CITY OF DUPONT

Project: Sequalitchew Creek Restoration Plan
Subject: Request for Information
File No.: PLNG2023-007 and -008

Re: Sequaltchew Creek Restoration Plan: Third-Party Review

TO: Lisa Klein, AICP, AHBL, Inc.
FROM: Ben Lee, PE, CWRE
DATE: April 30, 2024
RE: Hydrogeologic and Hydrologic Technical Peer Review
Sequalitchew Creek Restoration Plan
DuPont, Washington
Landau Project No. 1260016.020

Figure 9
Generalized Geologic Cross Section

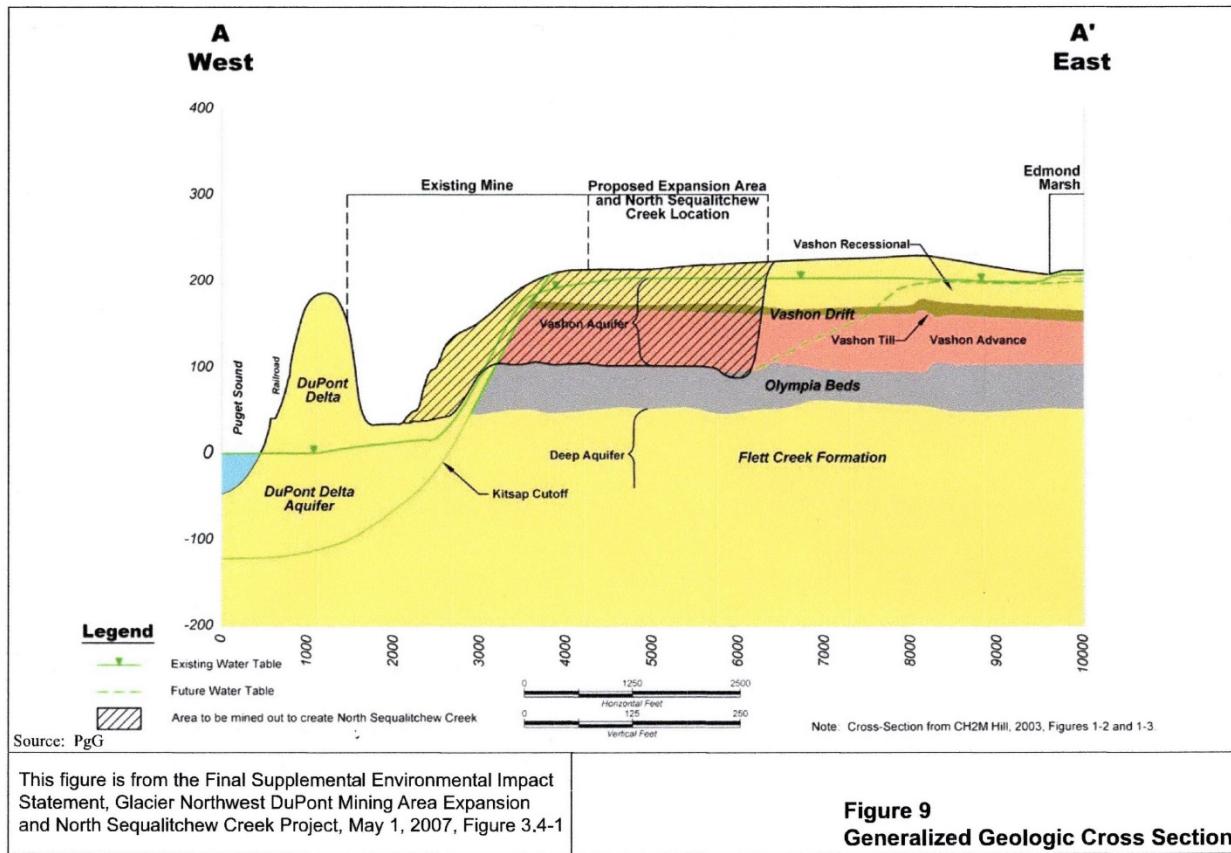
The results of CalPortland consultants' studies are shown in the above illustration, i.e., a ground and surface water drainage ditch constructed at the base of the southeastern wall of the south mine expansion area. This in mine drainage ditch was intended to discharge its comingled groundwater and stormwater runoff through a cut in the southwestern mine wall and into lower Sequalitchew Creek. This proposal was called the North Sequalitchew Creek project.
